Subject: Sanitary Waste Disposal via Holding Tank,
American Legion Post #205, Eastern Avenue, Augusta

Subject: Variance to the Maine Plumbing Code, Part II, American Legion property, Route 17, Augusta

Application For Subsurface Waste Water Disposal Permit

STATE VARIANCE FORM

Private Sewage Disposal Plan

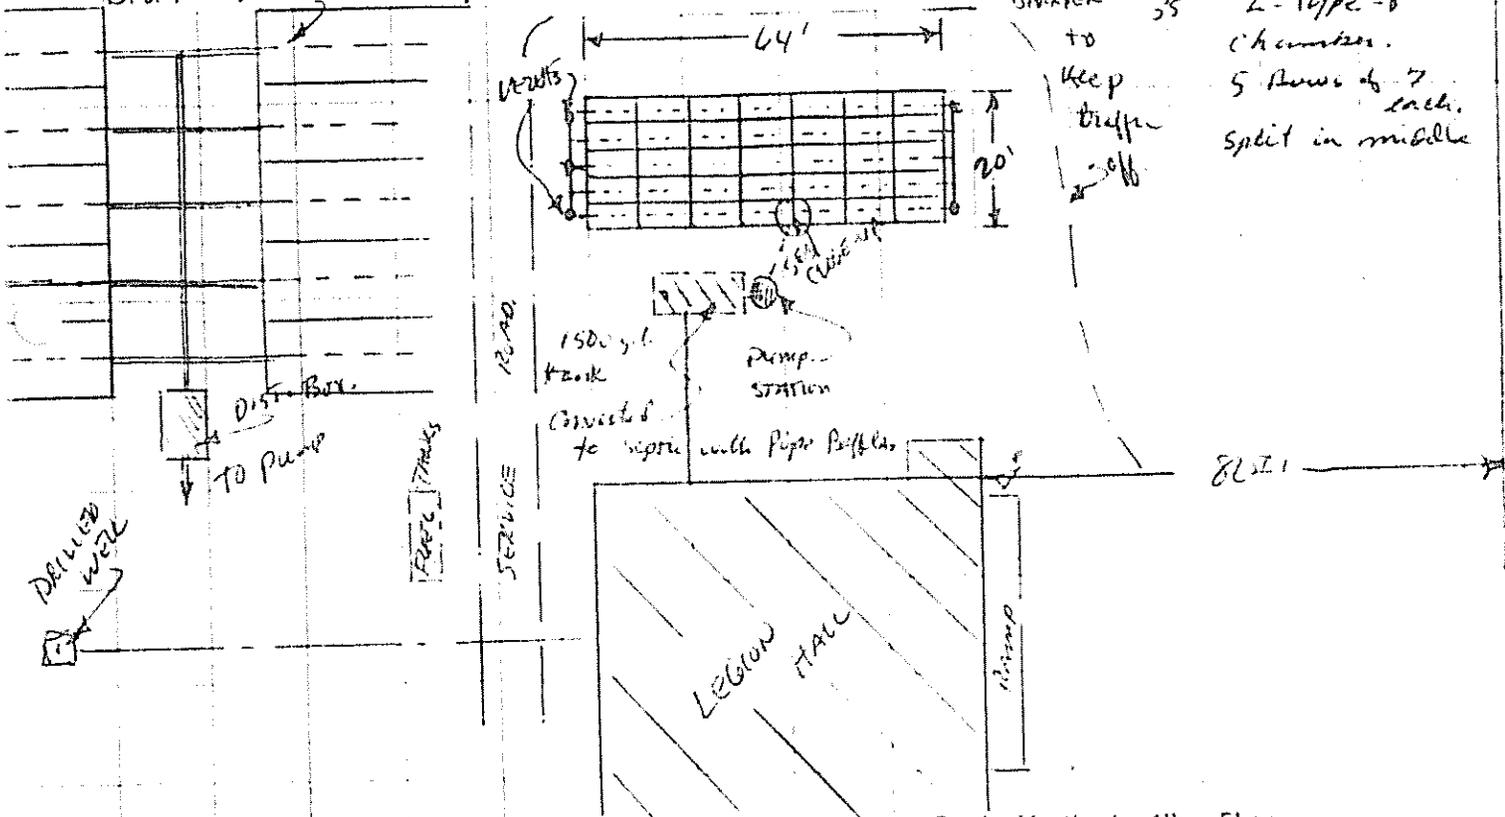
The proposed system design calls for 12 inches of fill material over the existing fill surface prior to installation of the chambers. This will maintain a greater than 12 inch separation from the bottom of the chamber area to any limiting factor.

1. That the actual installation of the system be done during a period when the fill material is very dry;
2. Under the area of the bed and the fill extension a layer of approximately 4 to 6 inches of sandy type material be placed and rotatiled into the existing fill material to encourage better infiltration of the wastewater;
3. That the 3 foot fill extension at a slope of 3% be extended a distance of approximately 7 or 8 feet.

The conversion of the existing holding tank into a treatment tank to service the structure. This conversion is acceptable provided that the liquid working capacity of the tanks is a minimum of 1500 gallons and that the baffles are installed in accordance with those required by the plumbing code. The effluent from this converted tank to flow to a pump chamber pumping to a cluster of 35 type 'B' chambers at a dose of 300 gallons.

At least 32 inches and 32 inches of fill shall be applied on the uphill and downhill sides of the disposal field, respectively. The fill shall be of a texture similar to the original soil and will provide a 12 inch separation between the bottom of the disposal bed and the seasonal high water table and impervious layer. The fill must be extended in all directions as required by Chapter 9 of the Maine Plumbing Code, Part II.
